April 17, 2009

Subject: Responses to February 19, 2009, EPA Letter Regarding the LTR Monitored Natural Attenuation (MNA) Summary Report

Attachment 4
Groundwater Contour Maps

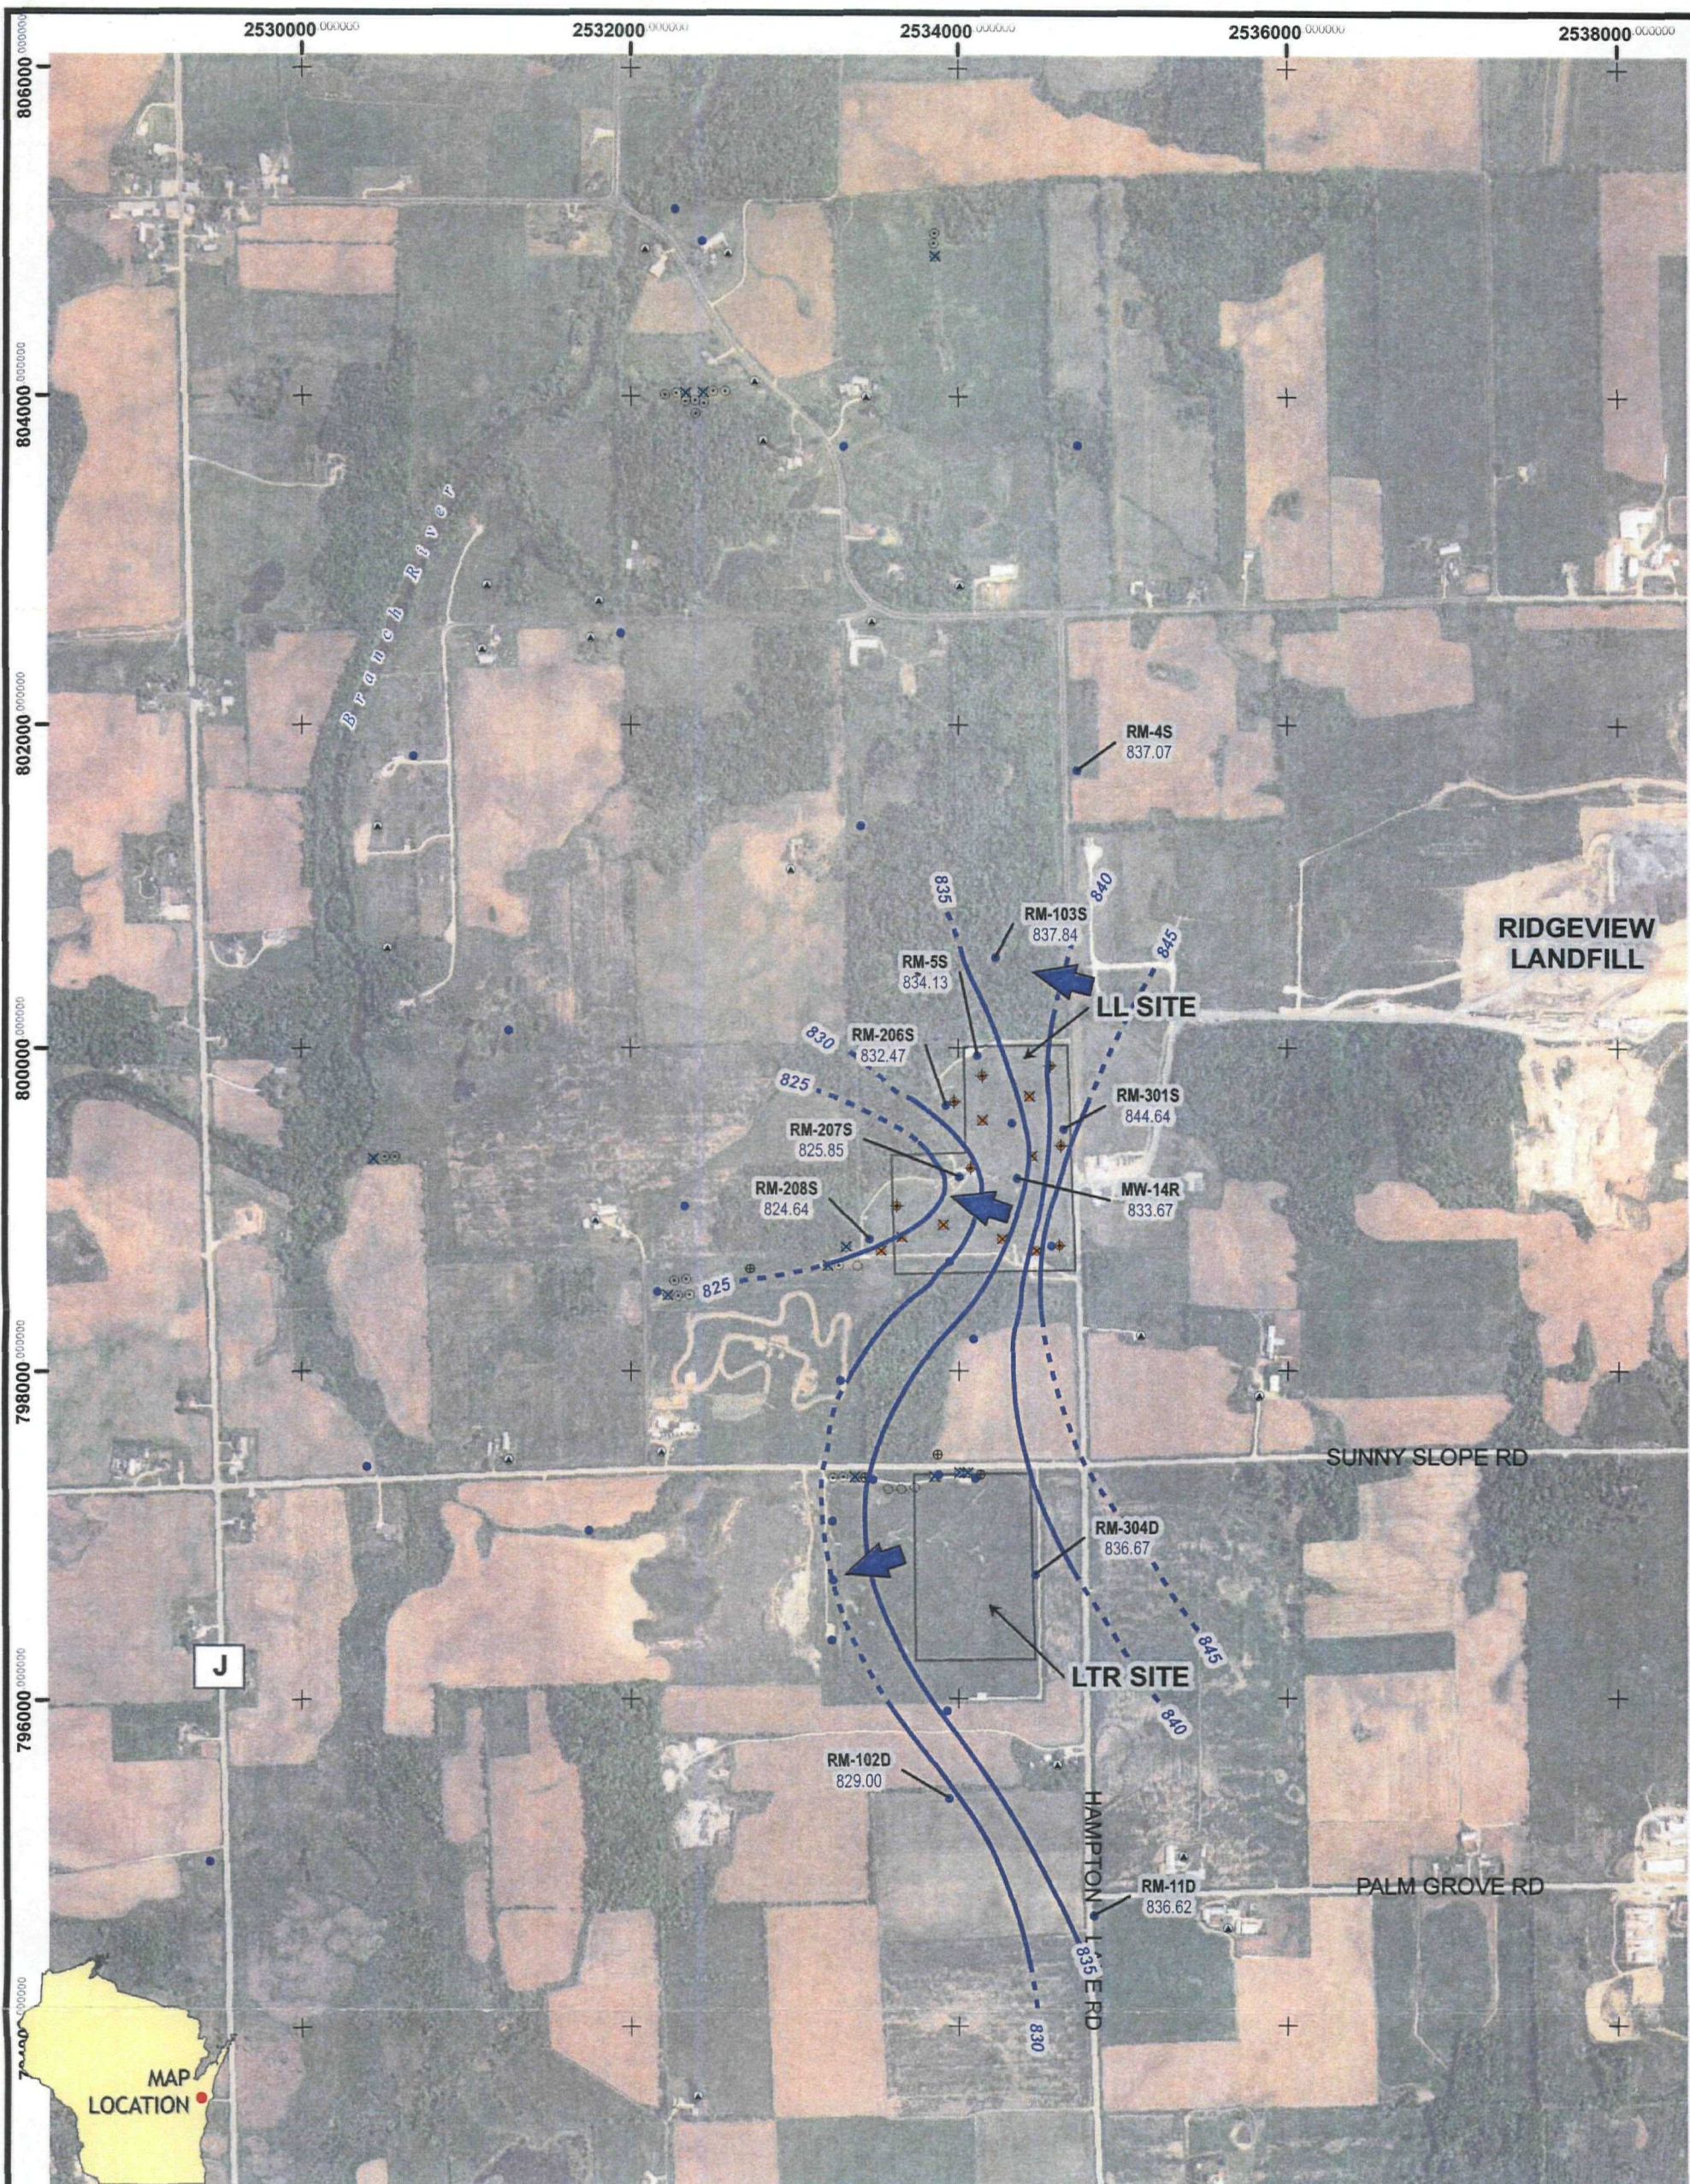
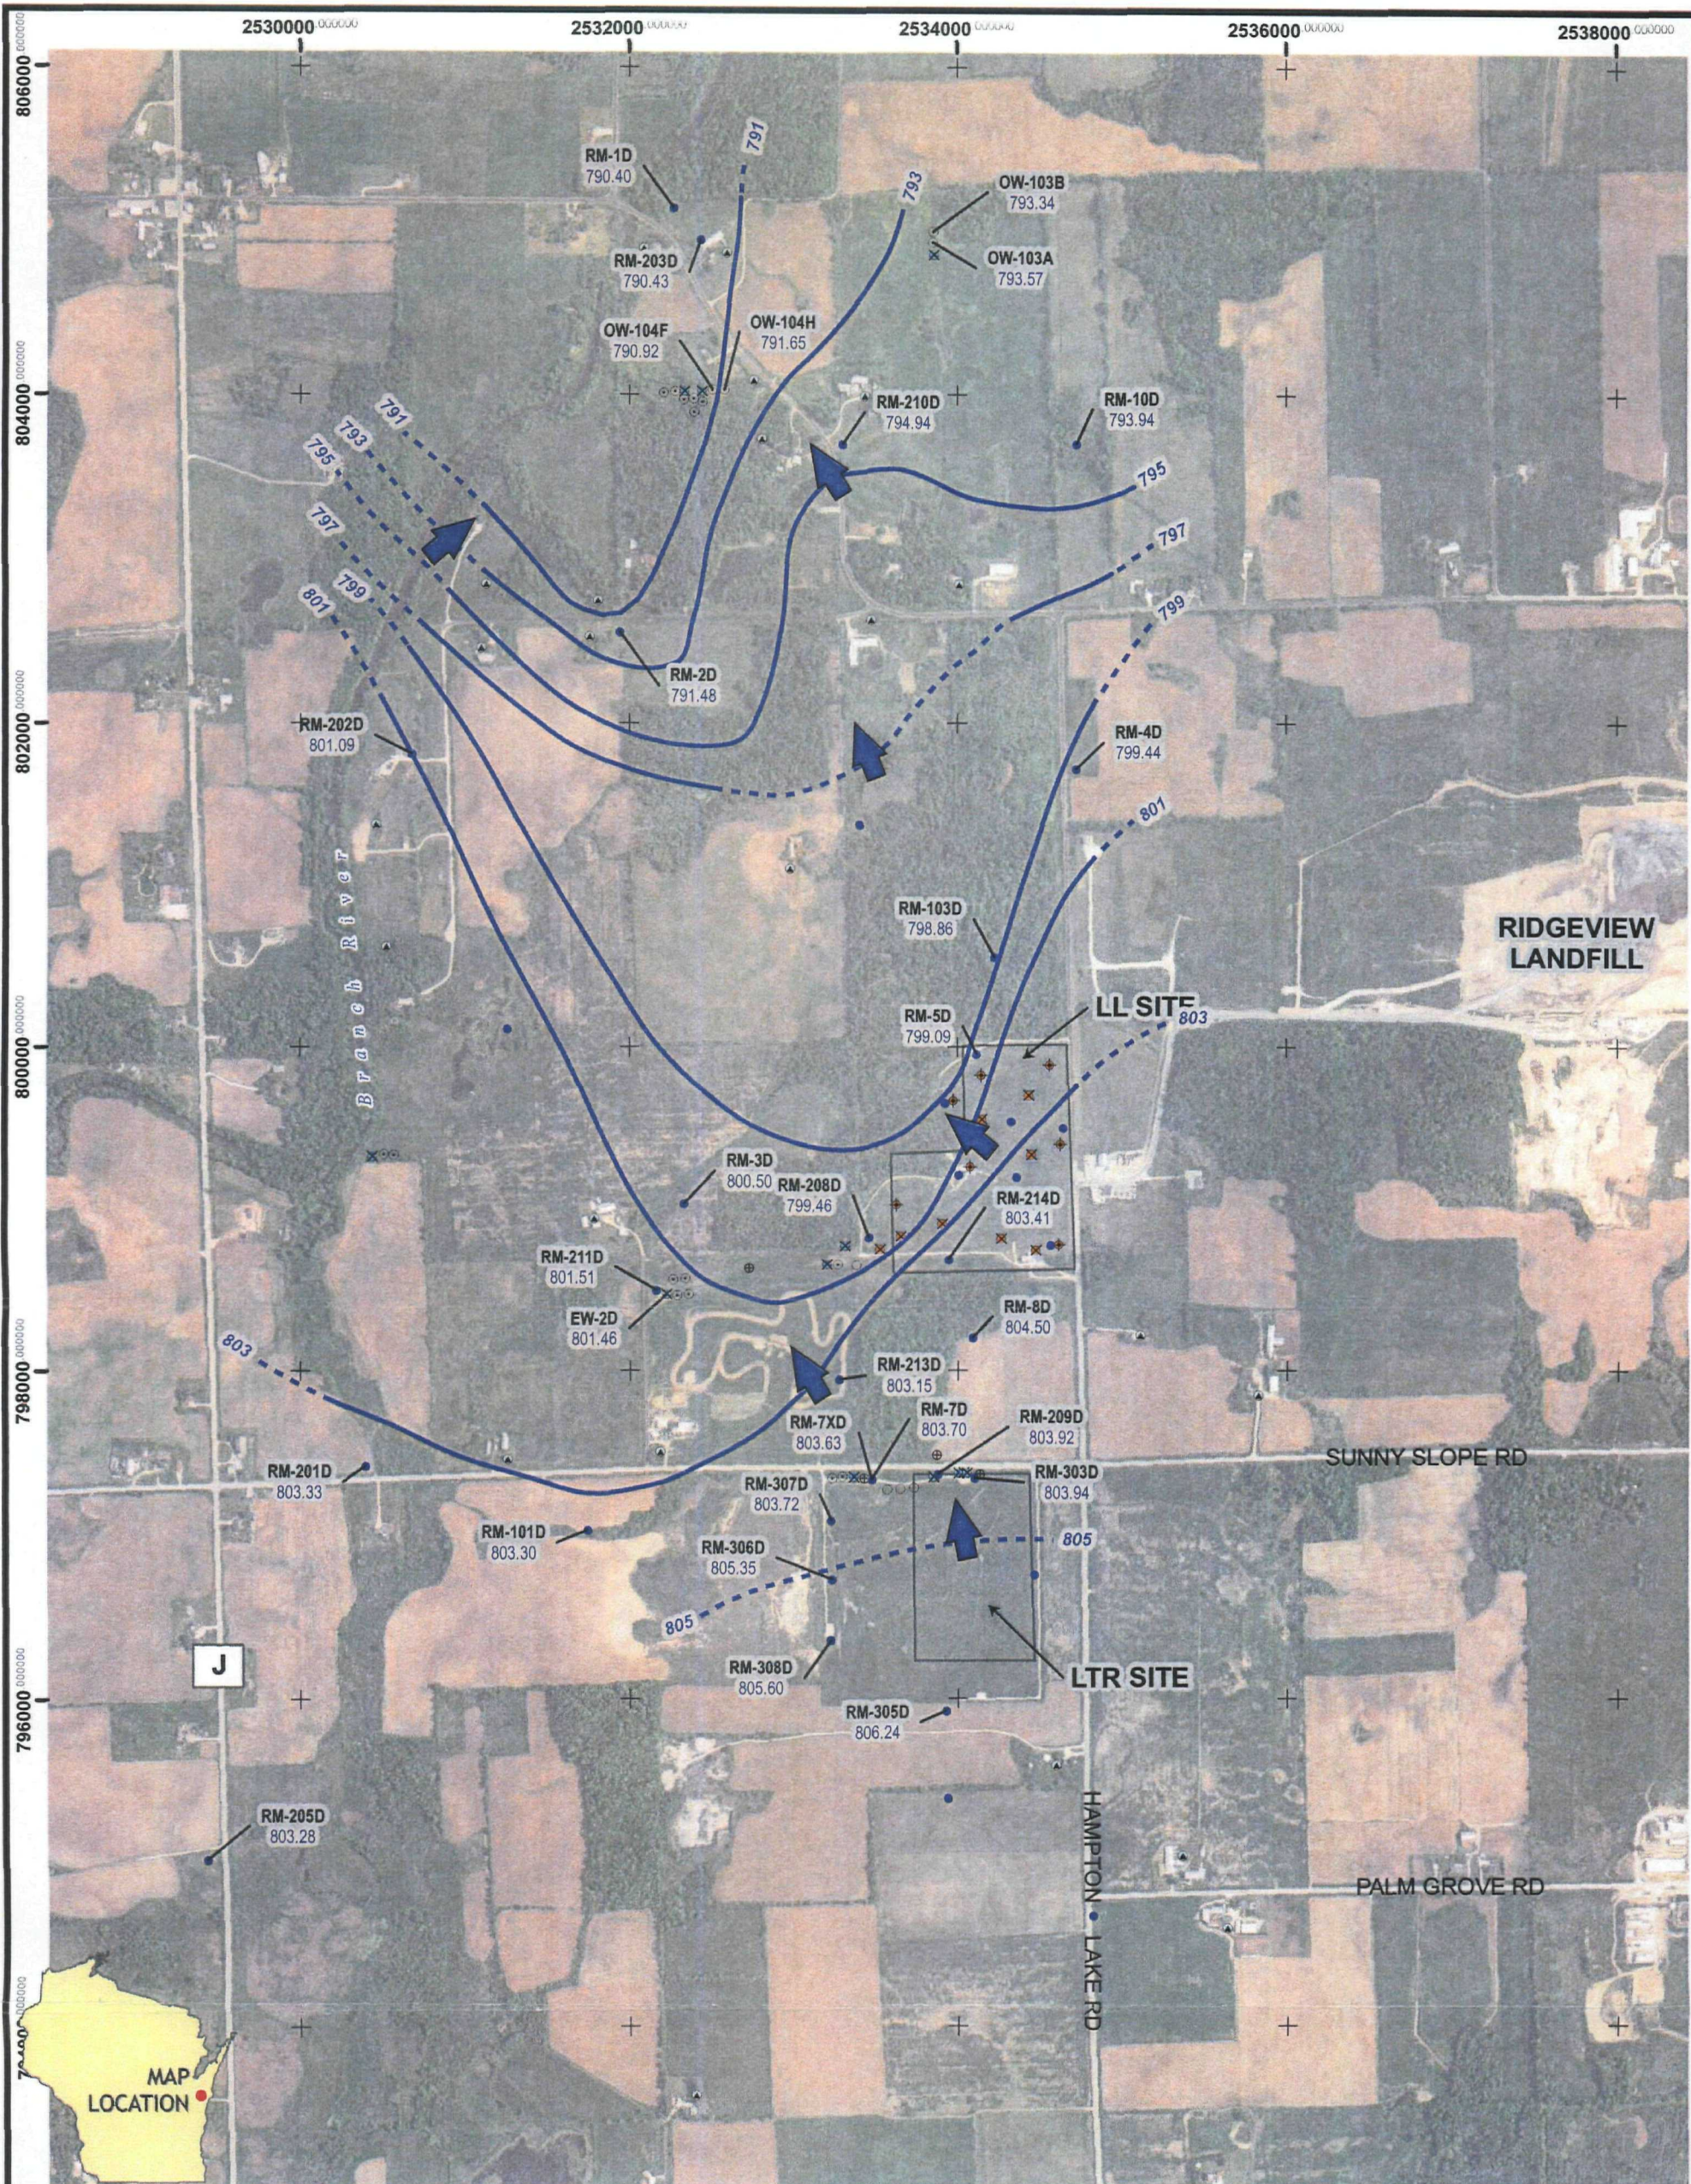
13. *Section 4.1.2: To demonstrate whether groundwater flow directions do or do not change with the season, potentiometric surface maps are needed for a high (spring) and low (winter) water level periods. Only the map for July 2008 was provided.*

Response: RMT has provided additional groundwater contour maps to demonstrate consistent groundwater flow directions (Attachment 4).
